## CITY OF SAINT PAUL

## All Comments Received from Charette Follow-up

**TABLE #1** **VICTORIA PARK**

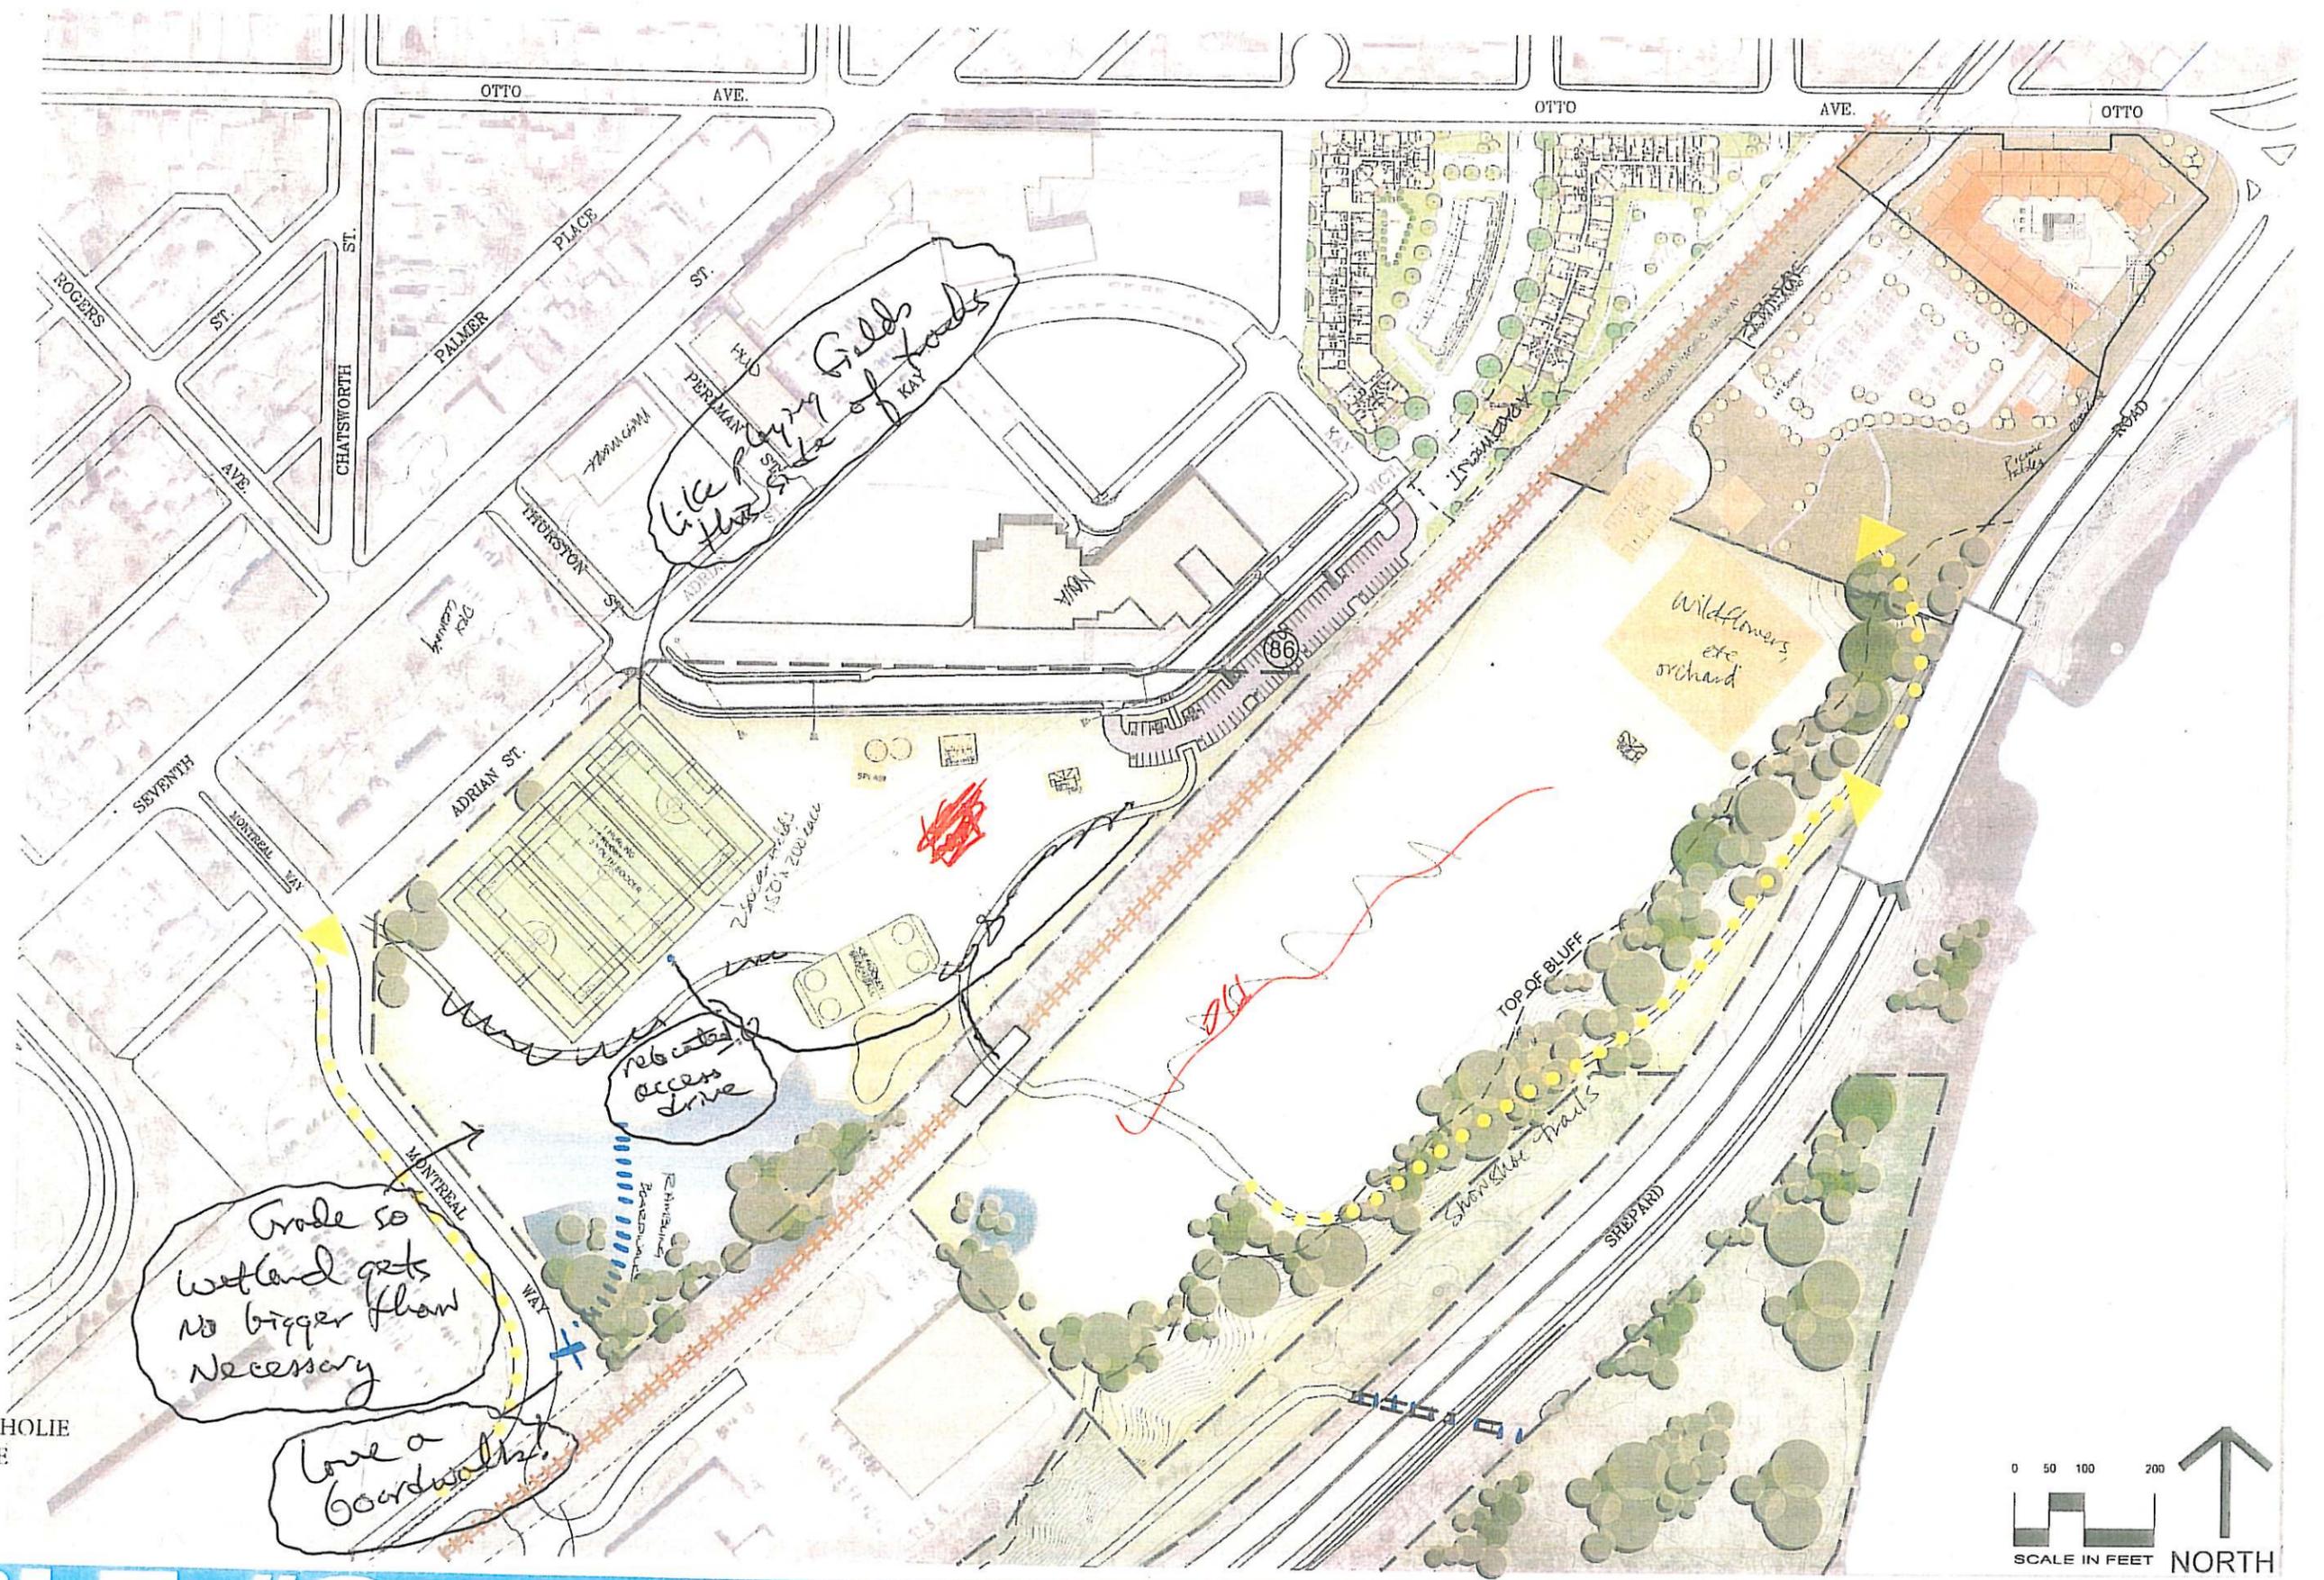
Kent Peterson  
Comments

Like bulk of  
Urban activities  
in the north section  
for table #1

Like parking in  
NW corner of park

Tennis courts &  
other shared  
uses

would like to see  
parking shared

I like this concept with  
more program  
to make it safer & activity  
exercise but walk/run circuit  
open shade - natural trails  
school natural history  
some

if open space  
is less turf  
more natural  
low berm

like this  
settlement

not  
appropriate at  
bluff edge

# TABLE #2

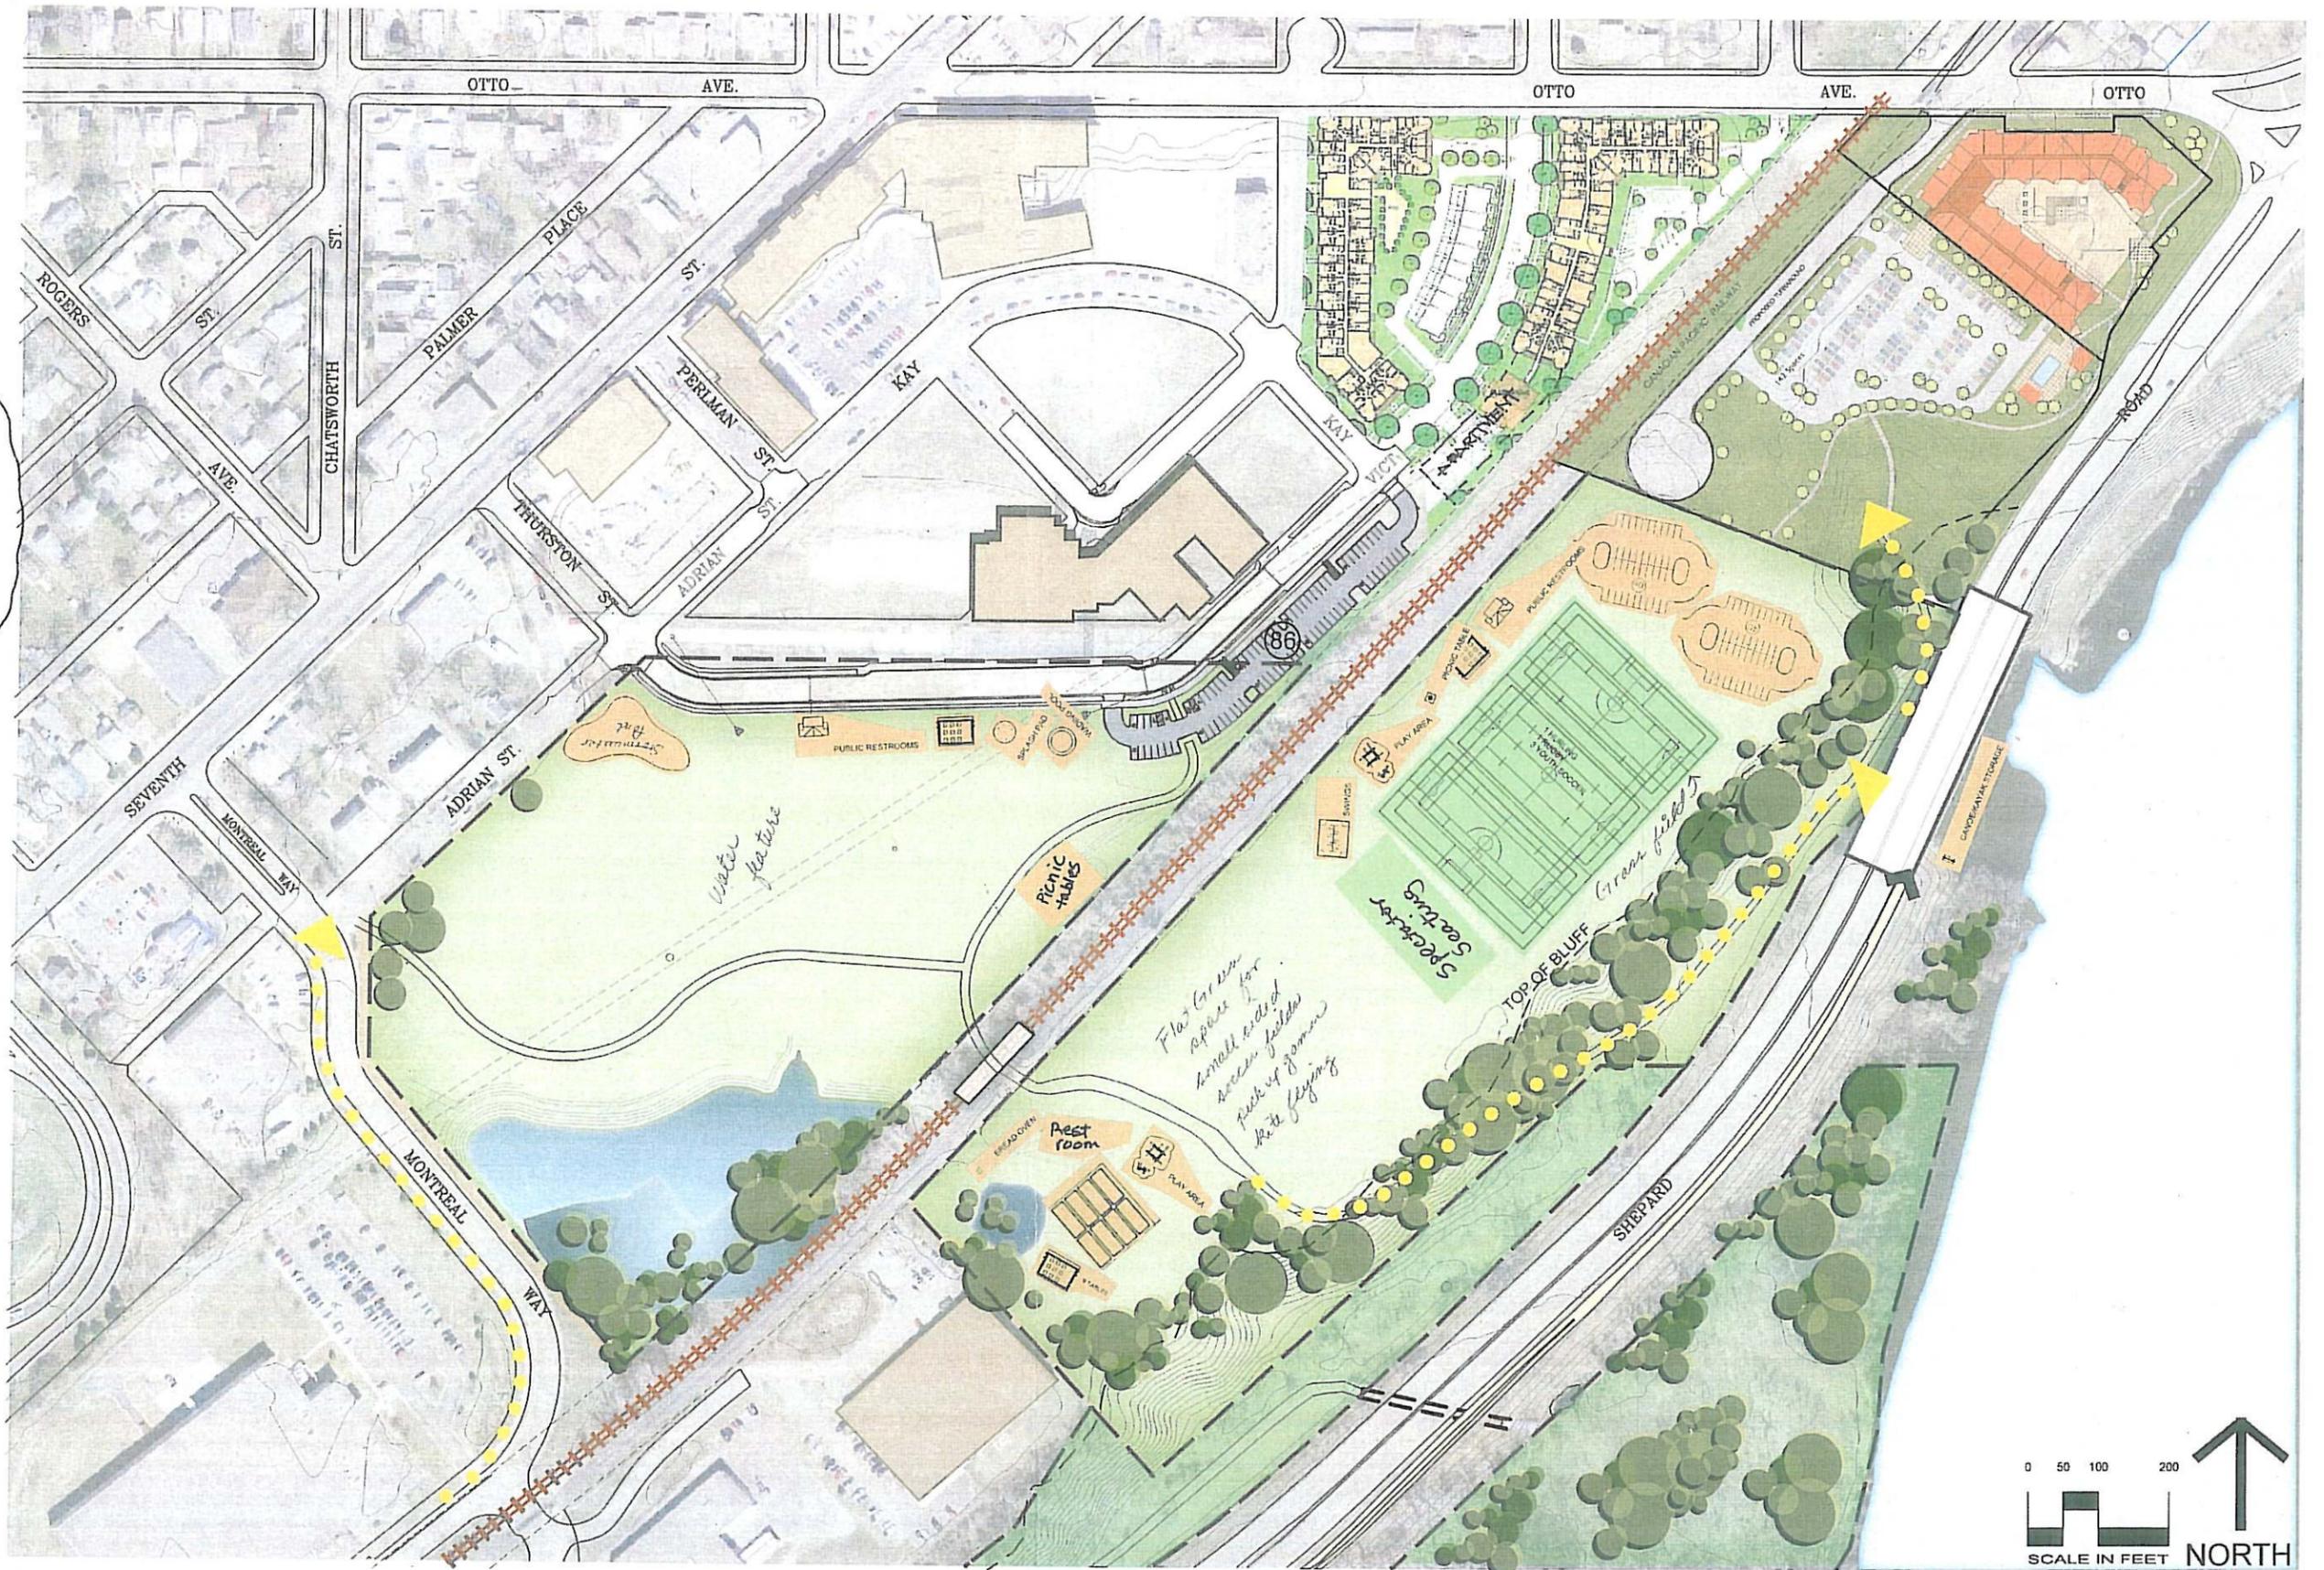
*Kent Peters*  
 Prefer to see, possibly, activities be ~~stop~~ stopped North/South Urban/Natural

**TABLE #3** **VICTORIA PARK**  
 Saint Paul Parks and Recreation design advisory committee  
 Project Manager: Don Ganje / Alice Messer  
 Contact: 651-266-6425 / 651-266-6412  
 Email: Don.Ganje@ci.stpaul.mn.us / Alice.Messer@ci.stpaul.mn.us  
 january 22, 2012 - MEETING #4

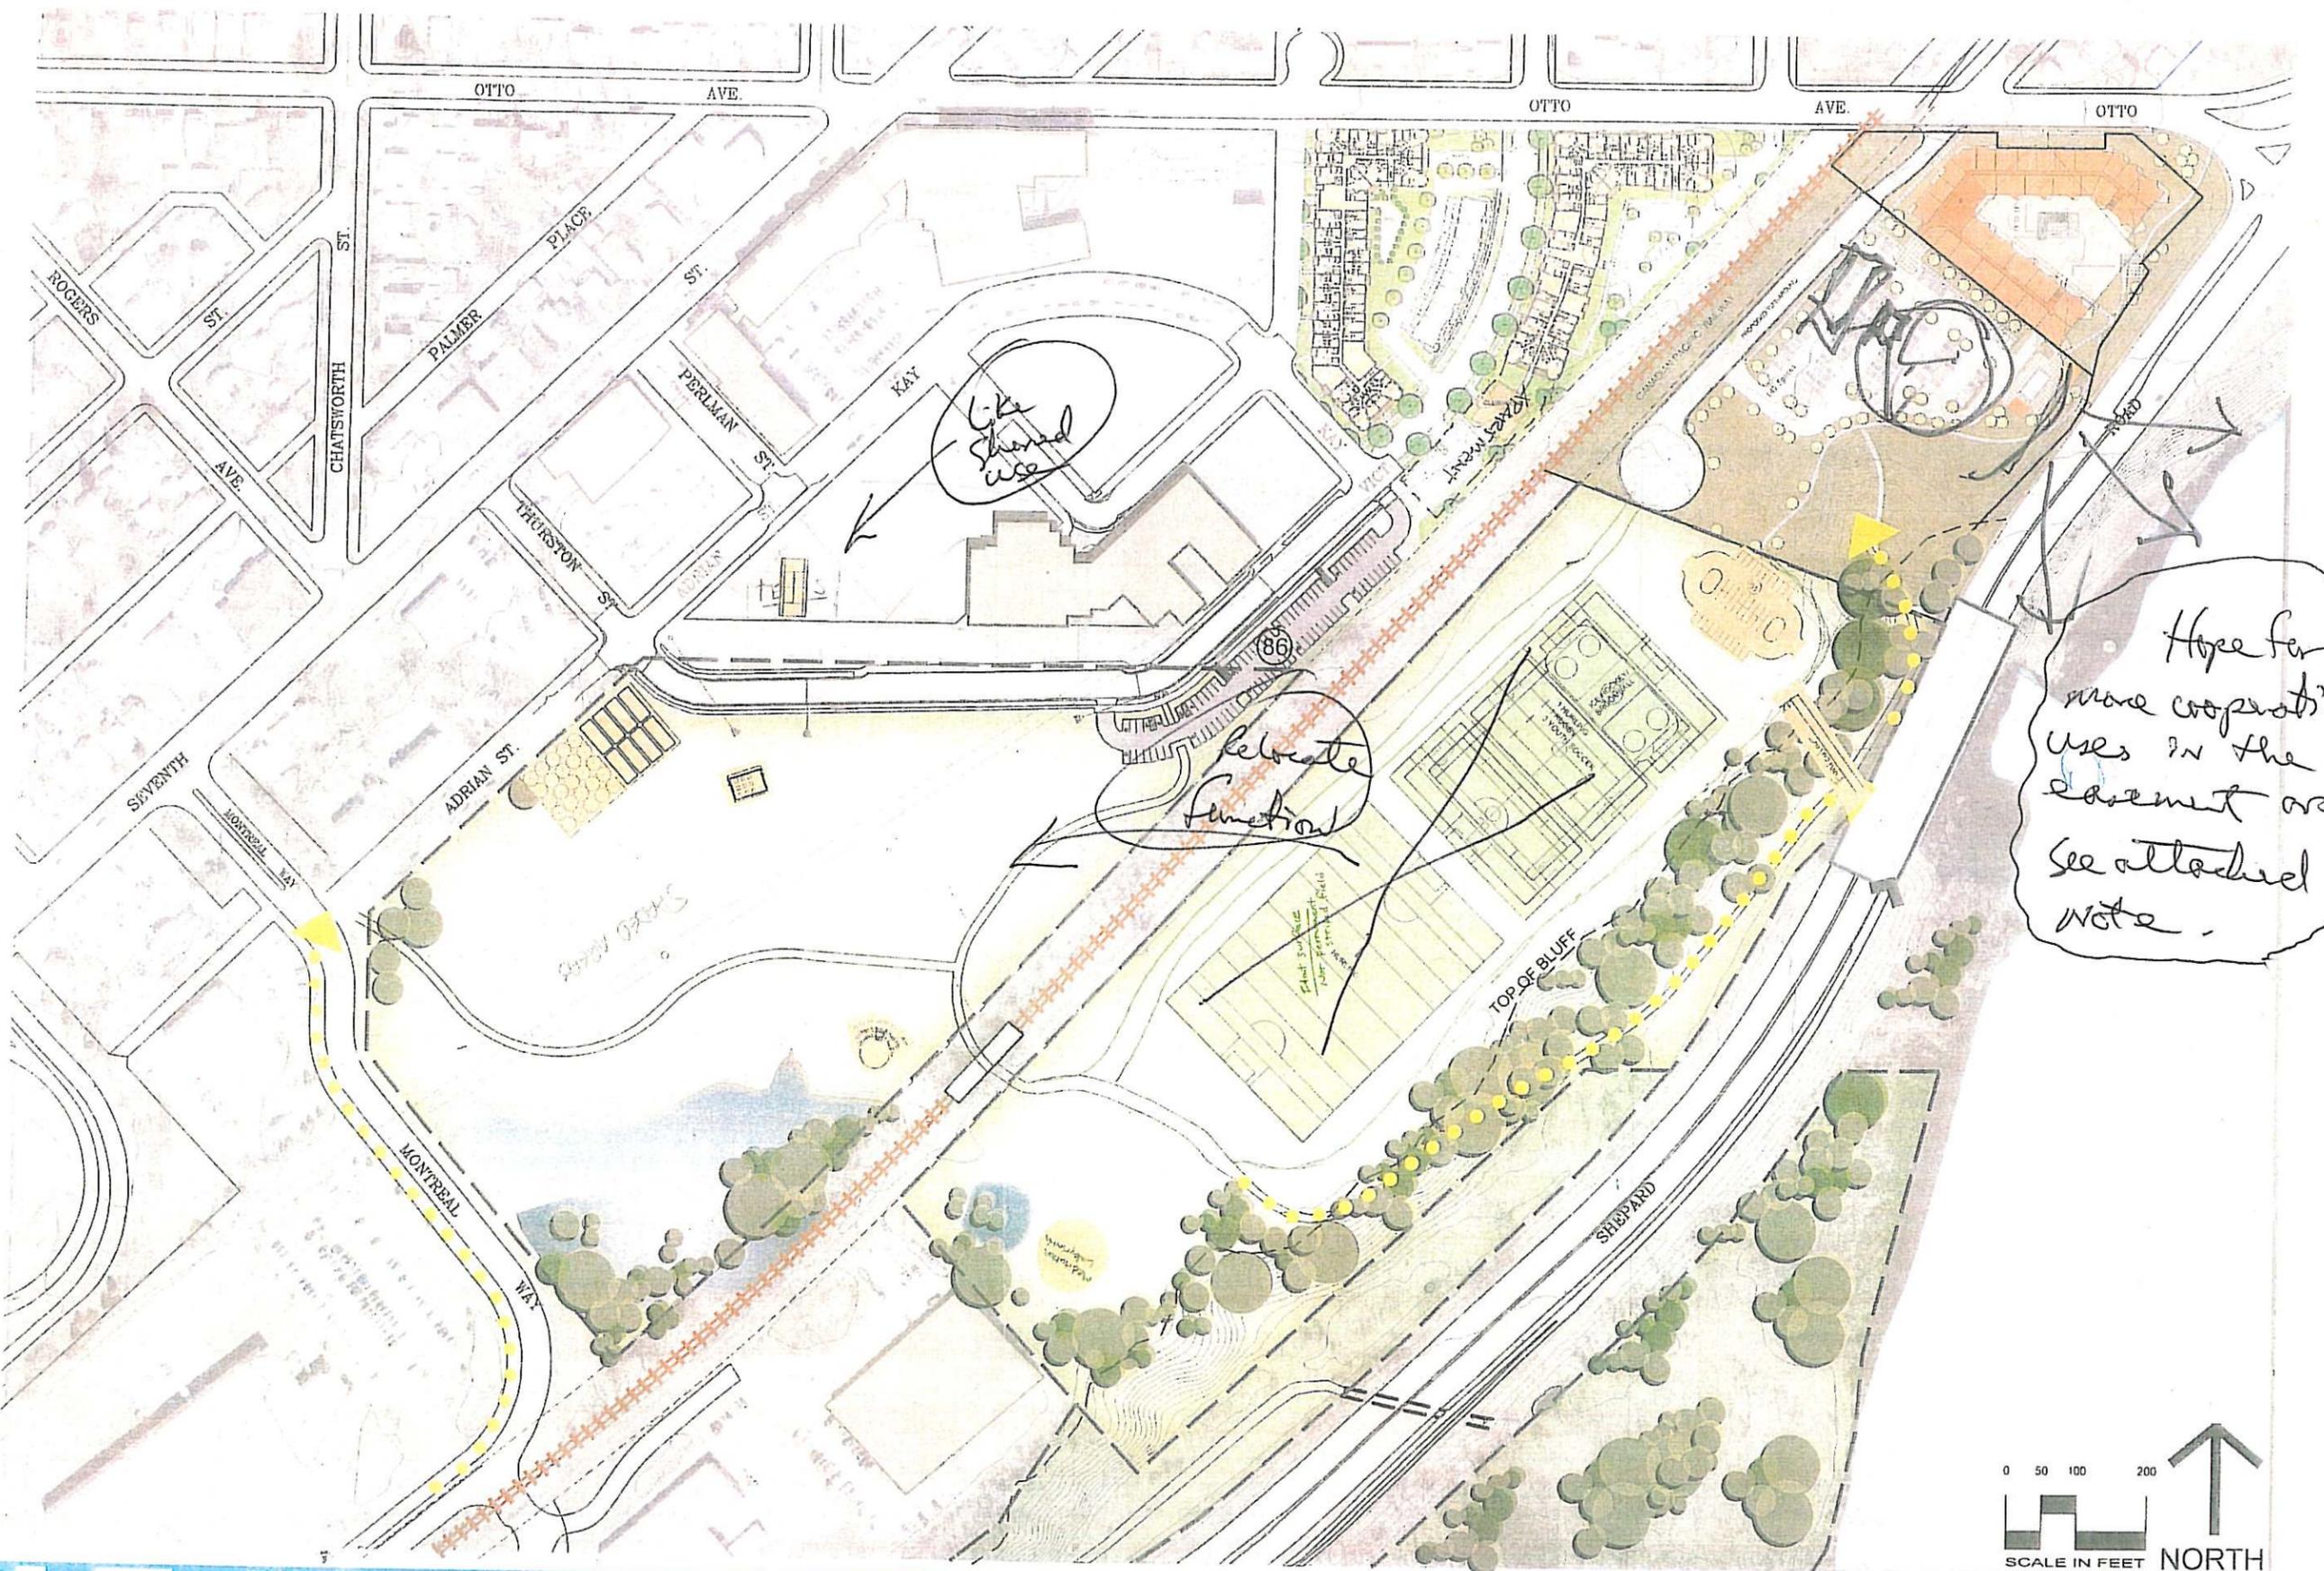
*Keep  
Pettus  
Comments*

*Here for  
more cooperative  
uses in the  
easement area  
see attached  
note.*
